Re: S/D 98-42 -- One-Step Final Plat of CUSTER ADDITION

Re: S/D 98-42 -- One-Step Final Plat of CUSTER ADDITION

STAFF REPORT
(One-Step Final Plat-Approved 5/7/98)

CASE NUMBER: S/D 98-42 - CUSTER ADDITION

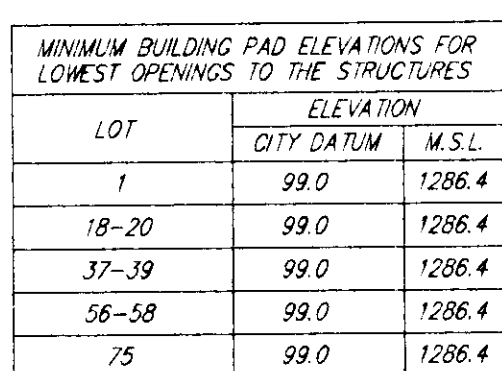
- C. City Engineering needs to comment on the status of the applicant's drainage plan. City Engineering needs to comment on the acceptability of the vacation of the maintenance access easement along the west line of the plat. The drainage plan is approved. The drainage improvements can be part of the paving guarantees. The 20-ft utility easement will be sufficient to cover the vacation of the maintenance access easement.

- D. The applicant shall guarantee the paving of the proposed interior streets. The proposed streets have been platted with a 60-foot right-of-way, which coincides with the streets platted in the surrounding developed area. A roadway width of 31 feet from back-of-curb to back-of-curb shall be required.

- F. City Fire Department needs to comment on this plat's street names. 29th Street South Circle should be renamed 29th Street Circle.
- G. The platter's text associated with the owner should be revised to correct the spelling of the word "lowest".

- P. The representatives from the utility companies should be prepared to comment on the need for any additional utility easements to be platted on this property. *KG&E has requested additional easements.*
